STAFF RECOMMENDATION

NCPC File No. 1303/6152

WASHINGTON MONUMENT GROUNDS FINAL SITE DEVELOPMENT PLANS FOR VISITOR AND SECURITY IMPROVEMENTS - LANDSCAPE PLAN

Submission by the National Park Service
May 29, 2003

Monument Plaza - Paving Pattern & Materials

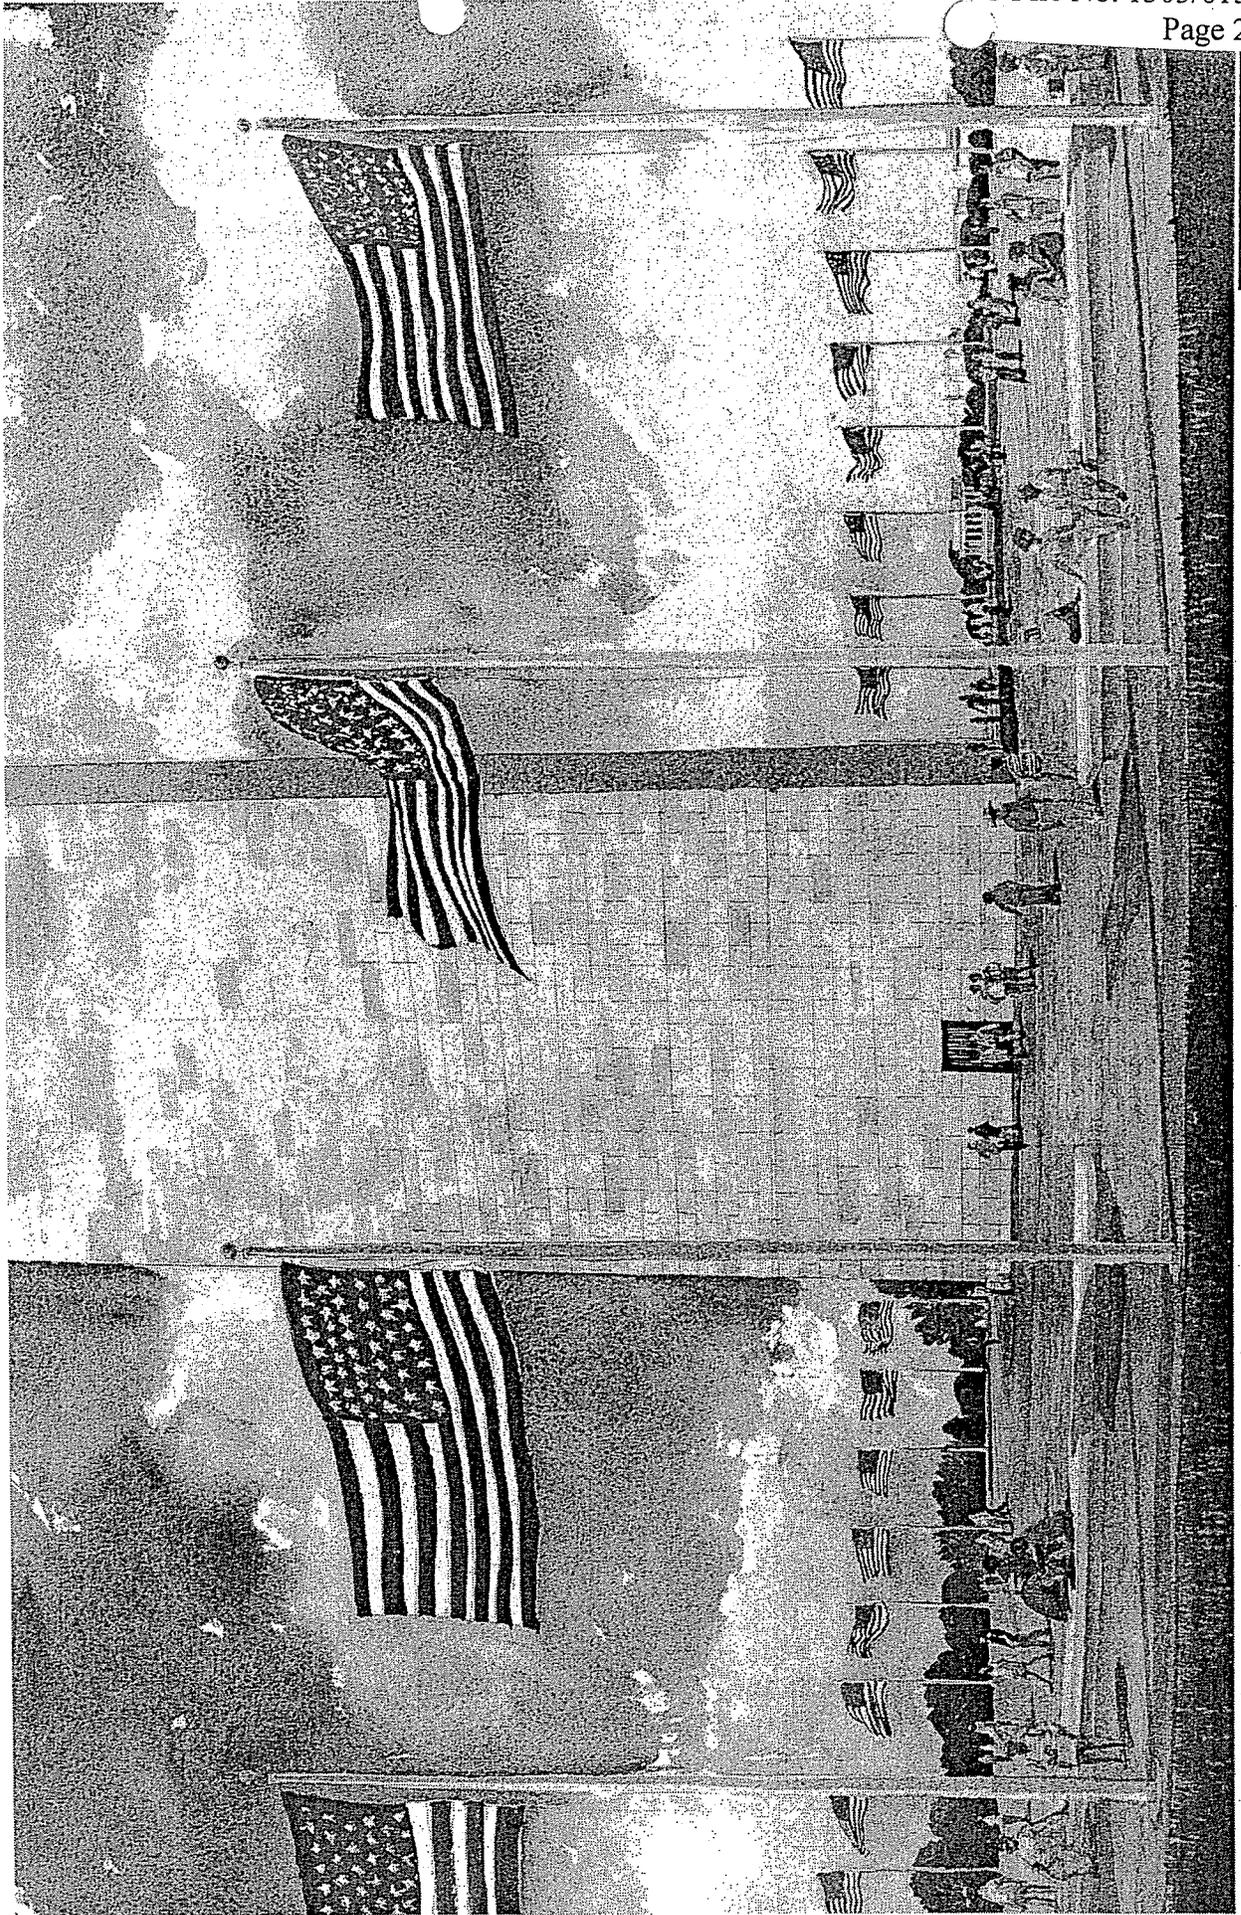
Approves the final site development plans for the landscape plan at the Washington Monument Grounds, as shown on NCPC Map File No. 1.42(38.00) 41180, provided the Monument Plaza be paved entirely in granite, rather than in granite and exposed aggregate concrete.

TREE REMOVALS & RELOCATIONS PLAN

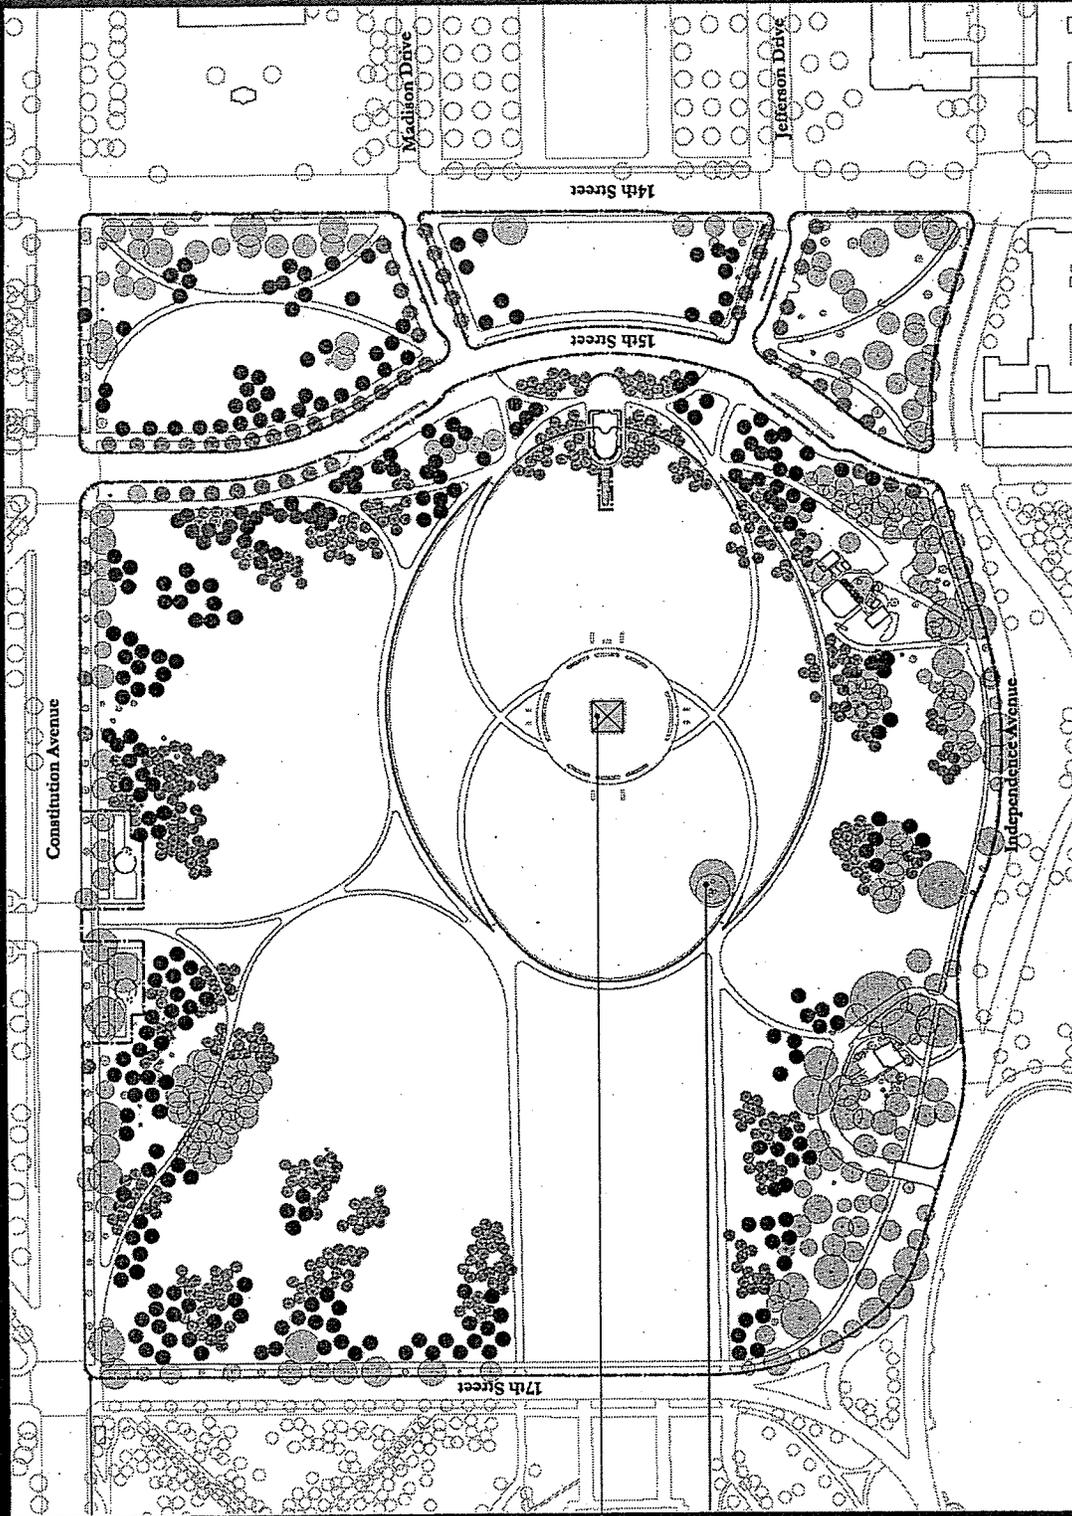
NPS proposes to remove or relocate 72 trees. Some are unhealthy and others will be removed to accommodate regrading and the construction of the paths.

The grounds used to be surrounded by street trees that died of Dutch elm disease. Disease-resistant American Elms will be replanted on both sides of Madison and Jefferson Drives, appropriately leading toward the lodge and the entrances to the grounds. The 1990s realignment of Madison and Jefferson Drives between 14th and 15th Streets that focused both drives inward toward the lodge is complemented by the proposed plantings of flowering trees around the lodge, underscoring the restoration of the lodge as a significant feature on the grounds. Street trees on 14th Street in the east-west vista would be appropriately removed.

TREE PLANTING PLAN

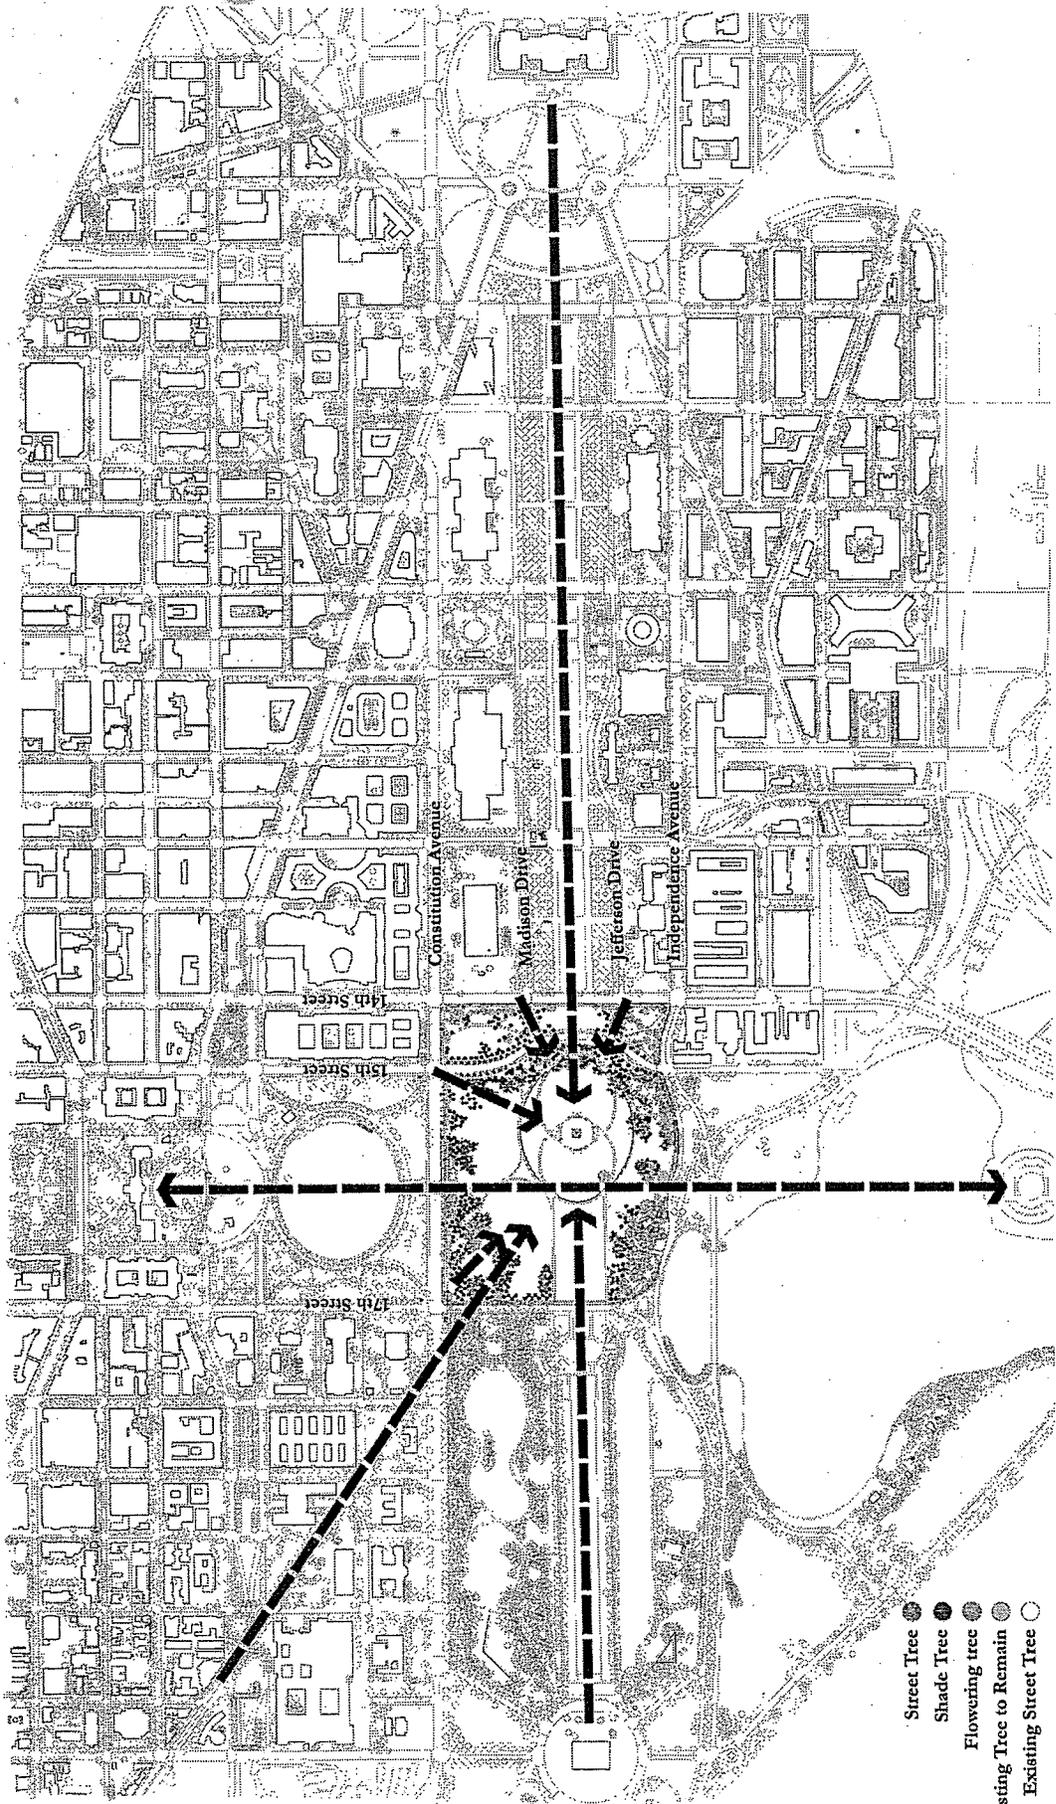
Placement of Street Trees: We agree that some refinement in the placement of the street trees proposed on 15th Street between Constitution Avenue and Madison Drive is appropriate since it has historically been part of the internal circulation rather than a boundary street. We agree that redistribution of trees into an informal planting of canopy trees with a stronger relationship to the curvilinear walks in the northeast quadrant of the Washington Monument Grounds deserves further study and look forward to consulting with your staff on the most appropriate location.

Trees on the Mall axis: The use of flowering trees around the Monument Lodge and its new addition is consistent with the historic character of the grounds, wherein structures were placed at the edge of the site within groves of trees and ornamental planting to diminish their visual prominence. We also proposed planting flowering trees in response to a perception that it would be desirable to filter views of the Monument Lodge addition. However, we are certainly open to studying a somewhat thinner or subdivided planting around the Monument Lodge and its addition. We believe that the most appropriate time to assess the number and location of the flowering trees is in the context of the design development of the Monument Lodge addition. As with the placement of the trees in the northeast quadrant of the grounds, we are looking forward to consultation with your staff.

- *Trees on the Mall axis.* The plan appropriately limits tree planting on the Mall axis to smaller flowering trees around the Monument Lodge. While the topography will reduce the visibility of these trees from a distance, a somewhat thinner or subdivided planting in this location may be appropriate to reinforce the continuity of the open east-west axis when seen from closer vantages.
